BECI Field Report

Perdido Sun
13753 Perdido Key Dr.
Pensacola, FL 32507

FIELD REPORT NO: **PRDDSN018**
CONSULTANTS PROJECT NO: **P140741899**

FIGURE 7 - Unit No. 200 - View of corner window removed.

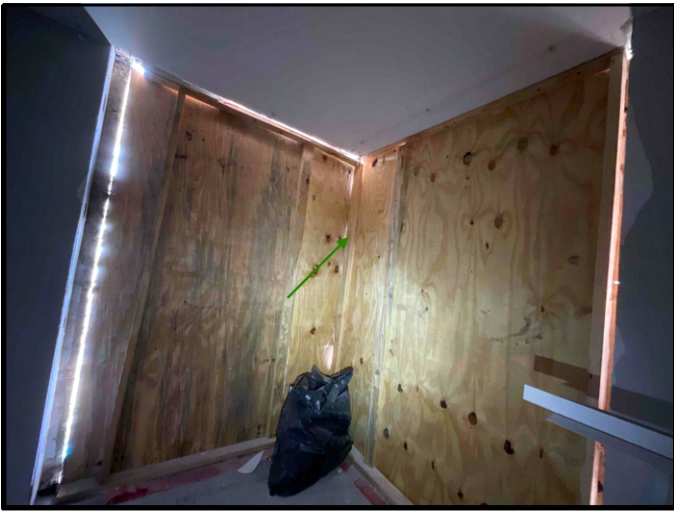
- 18.2.2 The South Corner windows presented two distinct jamb conditions. At the Eastmost jamb, the EIFS band at the edge of the concrete slab required the metal-framed jamb to be adjusted inward by approximately 2 inches to meet the required anchorage distance from the slab edge as indicated in the shop drawings. This adjustment had already been made in accordance with the detail provided by BECI in RFI #3. At the Westmost jamb, a wooden bucking was observed, consisting of two (2) 2"x4"s attached to a metal stud, with a previously installed 1x piece of lumber already removed. BECI provided detailed guidance for addressing these jamb conditions and advised that C/Sharpe consult with EFCO to confirm that the wooden substrate is suitable for current window anchorage provided in the Engineering Stamped Shop Drawings.

18.2.2 12/31/2024	12/31/24 - C/Sharpe is to address the jamb conditions in accordance with the detail provided by BECI in RFI #3 and C/Sharpe is to consult with EFCO to confirm that the wooden substrate is suitable for current window anchorage provided in the Engineering Stamped Shop Drawings.	New - 12/31/2024	N/A
